MANDATORY SERVICE BULLETIN

NO. MSB 40-070/1

Replacement of the passenger door retaining bracket

Retrofit Retaining Bracket

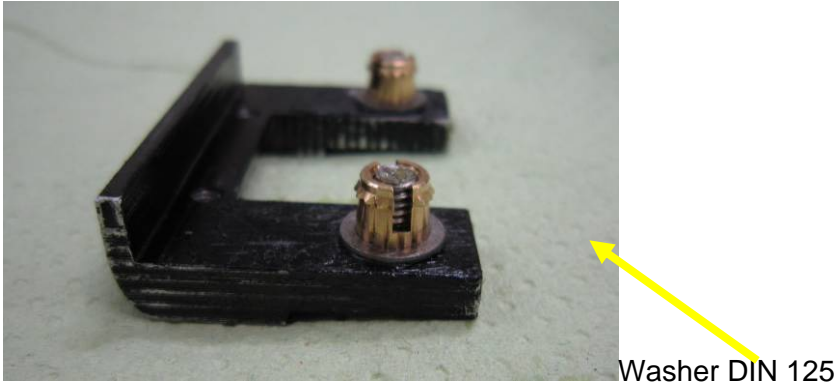
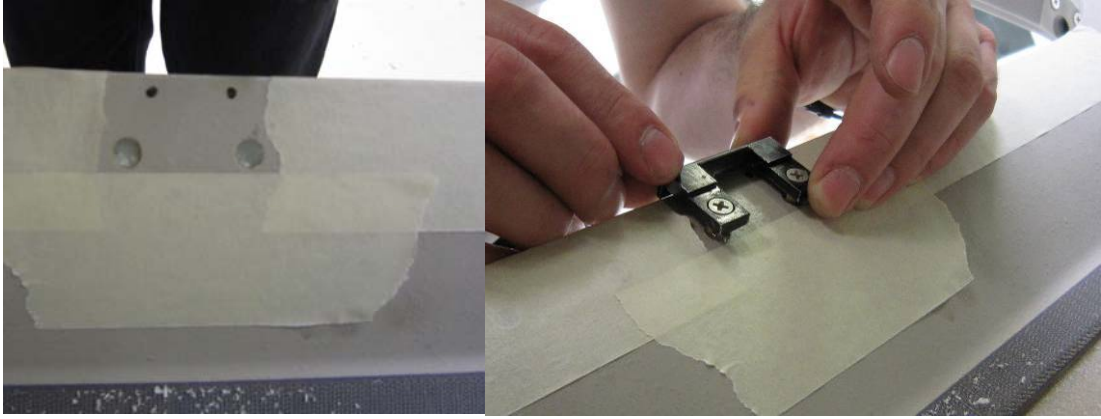
5	Remove the two screws from the fuselage which hold the Retaining Bracket (P/N: DA4-5200-00-69).
6	<p>Install the Retrofit Retaining Bracket (P/N: DA4-5200-00-69-SB) on the old position and mark the position of the two holes from inside the fuselage.</p> <div style="text-align: center;">  </div> <p>Note: Ensure the safety hook fits in the gap between the arms. If not fill the old holes with thickened resin and position the retaining bracket.</p>

7	Remove the Retaining Bracket and drill the two holes with a diameter of 7mm (9/32 inch) and a depth of 7mm (9/32 inch) on the marked positions.
8	<p>Prepare the Retaining Bracket for bonding the thread Insert. Grease the Retaining Bracket, the screws and the washers. Clean the thread insert from grease and dirt.</p>  <p style="text-align: right;">Washer DIN 125</p>
9	WARNING: When handling chemicals always observe Health and Safety Regulations given by the manufacturer of the chemicals.
10	<p>Fill the holes with the two-part adhesive MA300 or thickened resin (L20/H91 thickened with cotton flocks) and install the Retaining Bracket.</p>  <p>Note: L20/H91 mixture: 100 parts resin and 27 parts hardener (by weight). Supplier: Hexion Specialty Chemicals Stuttgart GmbH.</p> <p>Caution: Follow the instructions given in the material data sheet and obey the material safety data sheet.</p>
11	If bonding with Plexus: Cure the installation for one hour. If bonding with resin: Cure 4 hours and post cure 8 hrs 60°C (140°F).

12	Install the Retaining Bracket with screws DIN 963 M3x12-A2-BC and DIN 965-AM4-10-A2.
13	Check function of door locking mechanism i.a.w. AMM Section 52-10.
14	Clean the working area and check for foreign objects.
15	Make necessary entries into aircraft logs.
